Contra Costa County Zoning Administrator

Staff Report

Project Title: Delta Coves Three Lot Minor Subdivision

County File(s): CDMS24-00015

Figure 2: CDMS24-00015 USGS Geologic Map

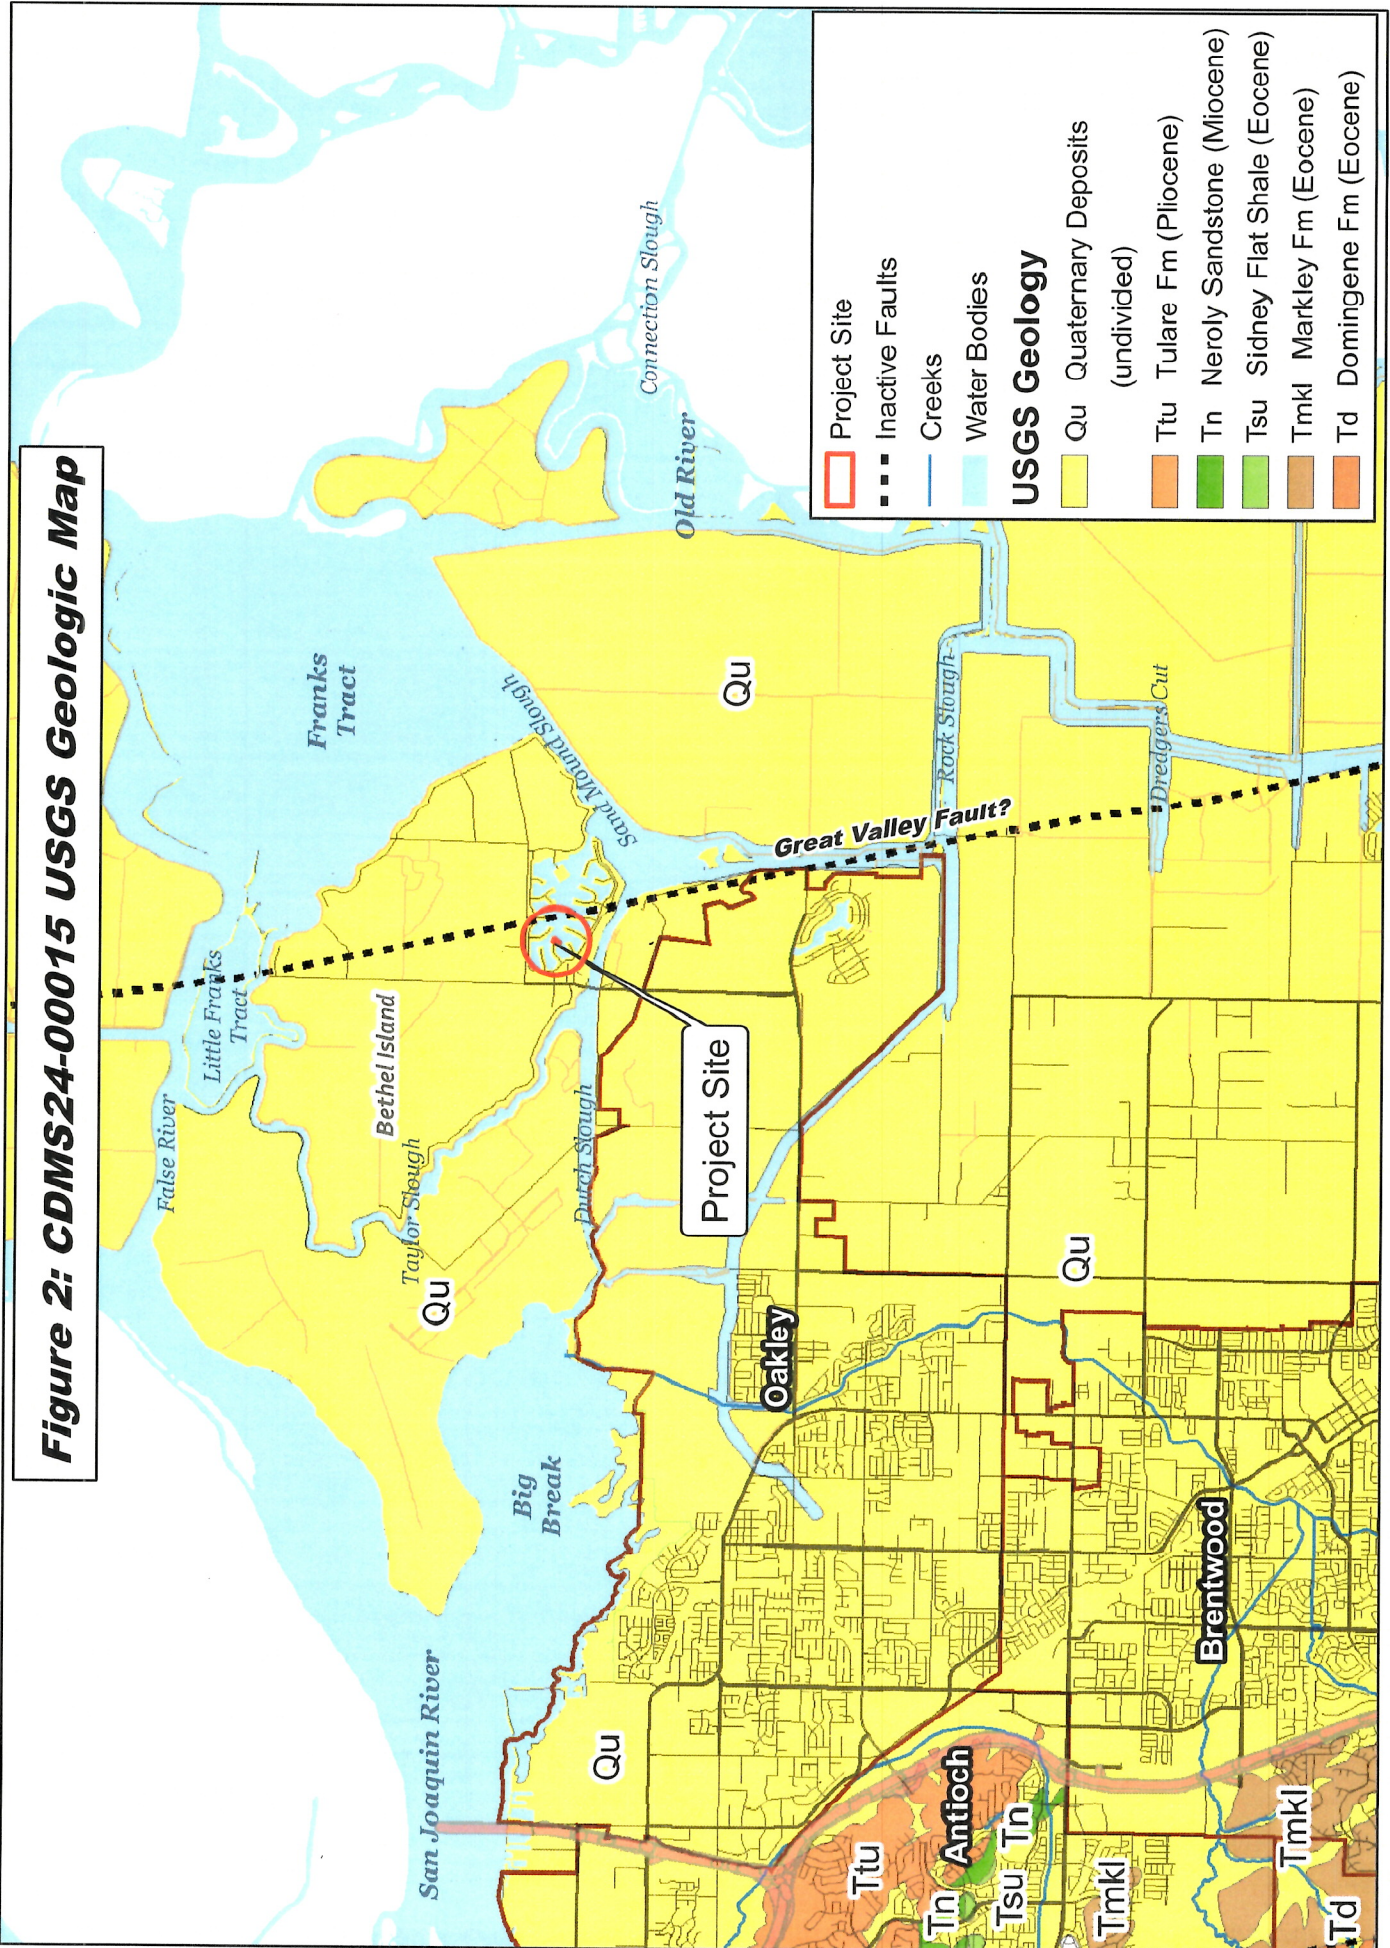
In 1994 the USGS issued a digitized bedrock geology map of Contra Costa County. Figure 2 presents a portion of this map. The base map shows the local road network and water bodies (blue color). The USGS maps the site and other lands on the valley floor as Quaternary deposits, undifferentiated (Qu). The nearest bedrock is indicated to be 7½ mi. southwest of the site. These formations range in age from Pliocene to Eocene. The depth to bedrock beneath the project site is unknown but may exceed 300 ft. below the ground surface.

Figure 3: CDMS24-00015 USGS Quaternary Geology Map

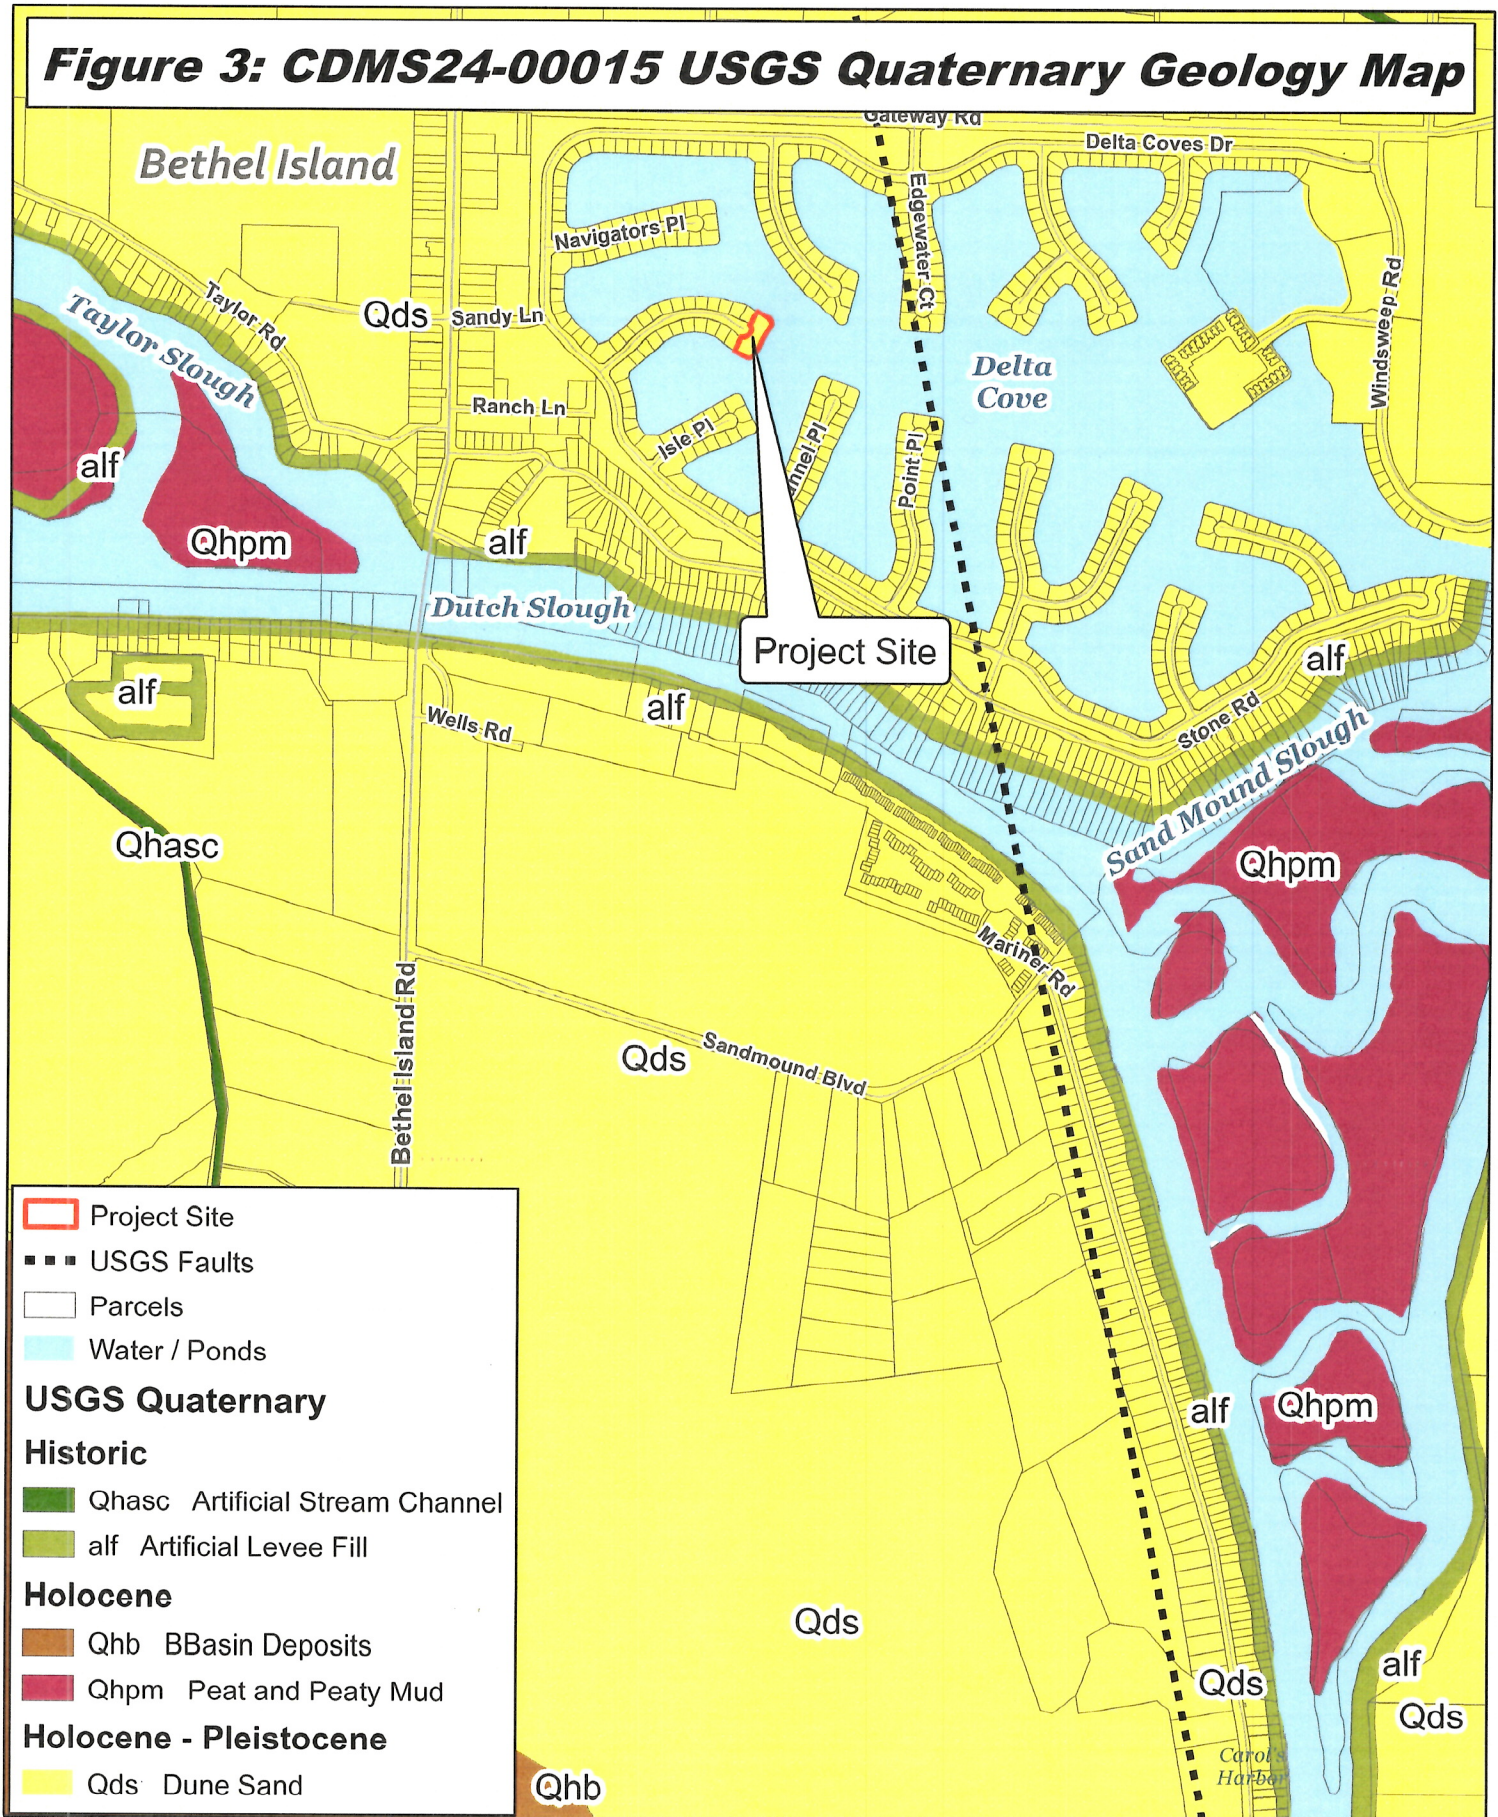
In 1997 the USGS issued a map that divided Quaternary deposits of Contra Costa County into nine categories that vary in age, depositional environment and engineering properties.⁵ A portion of this USGS map is presented in Figure 3 at a scale of 1 in.= 1,000 ft. Five different surficial deposit units are mapped on the Delta lowlands. The legend for Figure 3 divides these units into groups according to age (i.e. from Historic deposits to units of Holocene and Holocene/Pleistocene age). Table 2 presents a brief description of these units. According to Figure 3 the project site is located within an area mapped as *Dune Sand* (Qds). This unit is of Late Pleistocene and Holocene age. It consists of fine-grained, very well-sorted, well-drained eolian deposits. They occur mainly in two large northwest-southeast trending sheets as well as many small hills, most displaying Barchan morphology. Qds is inferred to have begun accumulating after the last interglacial high stand of sea-level began to recede about 71 ka and continued to form when sea level dropped to its Wisconsin minimum (estimated to be 18 ka), and probably ceased to accumulate after sea level reached its present elevation (est. to be 6 ka). The dunes display as much as 30 meters of erosional relief and in many areas, they are overlain by basin deposits (Qhb) and peaty mud (Qhpm) of Holocene age. Additionally historic deposits include *Artificial Levee Fill* (alf) and *Artificial Stream Channel* (Qhasc).

Figure 4: CDMS24-00015 Seismic Hazard Zone Map

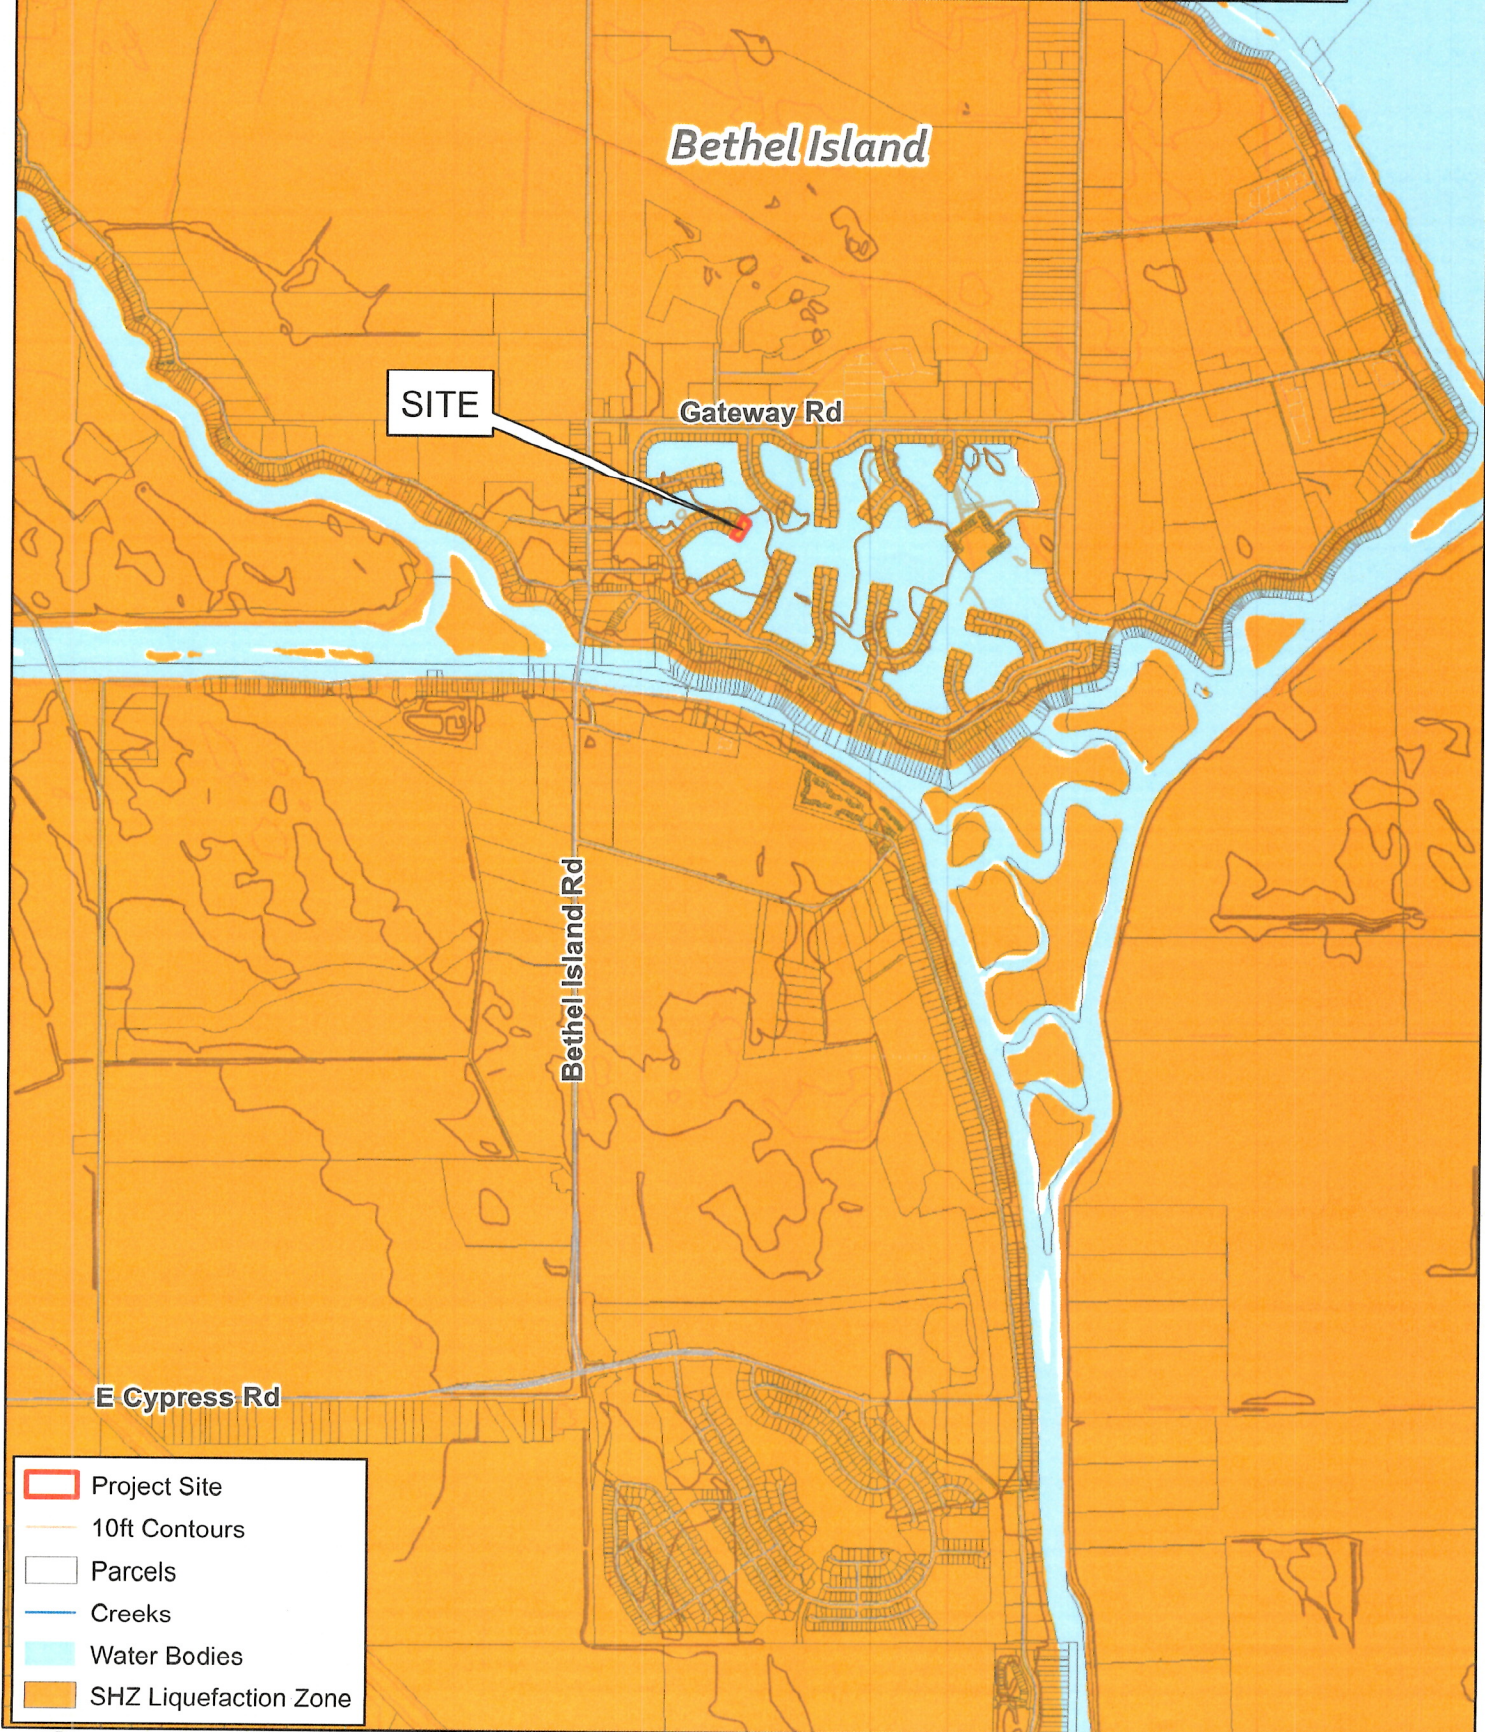
Figure 4 presents a portion of the Jersey Island 7.5-Minute Quadrangle. SHZ map showing the project site and vicinity (scale of 1 in.=2,000 ft.). This map was adopted by the State Mining and Geology Board on January 11, 2018. The boundary of the project site is shaded red and centered within a red bullseye; the base map shows the local road network, water bodies (blue) and topography (10 ft. contour interval). As shown, the project site is within an *Earthquake-Induced Liquefaction Zone*. In making its determination the CGS considers the engineering properties of the various Quaternary deposits known to occur in the subsurface, available information on the elevation of the water table, and local seismic conditions. In this

case, deposits known to occur in the subsurface are water saturated Dune Sand. The adopted SHZ map requires rigorous evaluation of liquefaction potential that follows guidelines presented in CGS Special Publication 117A.⁷ The SHZ Report provides background information utilized in preparation of the SHZ map, including the geology and seismicity of the Quadrangle map and the methodology used to provide evaluation of liquefaction potential. Using this approach, the CGS prepared a map that forecasts peak ground acceleration (PGA). That was used in the liquefaction analysis of the CGS. SHZ Report 121 (Plate 3.2) indicates that the Project Site is within an area rated as having a Probabilistic PGA of 0.23 - 0.24g's (i.e., 10% risk of exceedance in 50 years). For lands rated at-risk of liquefaction, there is a potential for permanent lateral and vertical ground displacements such that mitigation as defined in Public Resource Code Section 2693c is required. Disclaimer #8 on the SHZ map acknowledges that some sites within the designated hazard areas may have already been mitigated to standards of the local jurisdiction (i.e., the CGS has not performed exhaustive studies of previous geotechnical and engineering geologic reports).

As previously noted, the Seismic Hazard Zone (SHZ) Map considers the project site and all properties parcels on Bethel Island to be within an area that is at-risk of liquefaction and associated ground failure. Rigorous site-specific studies and needed to evaluate liquefaction. Where liquefiable soils are confirmed to be present in the subsurface, effective mitigation of the hazard posed to new development is required. Operative General Plan policies are presented in Table 3. Note that Policy 10-21 has the following components: (i) define and delineate the hazardous geologic and/or soils conditions, (ii) recommend means of mitigating the adverse conditions that were confirmed to be present on the site, and (iii) identify the means to assure that the recommendation presented in the geotechnical/ geologic report are properly interpreted and implemented by their client and the client's contractor.

- a. Submittal of a *Geologic Hazard Report* that identifies potentially hazardous conditions (in this case, analysis of liquefaction potential, along with any other hazards that may exist, such as expansive and corrosive soils, slope stability, etc.),
- b. Recommend means of any adverse conditions that were confirmed to be present on the site, and
- c. During the construction process, provide documentation of the implementation of all mitigation measures (i.e., the *Geologic Hazards Report* shall include recommendations for construction monitoring and testing to ensure that the client and contractor properly interpret and implement all geo-related mitigation measures.)
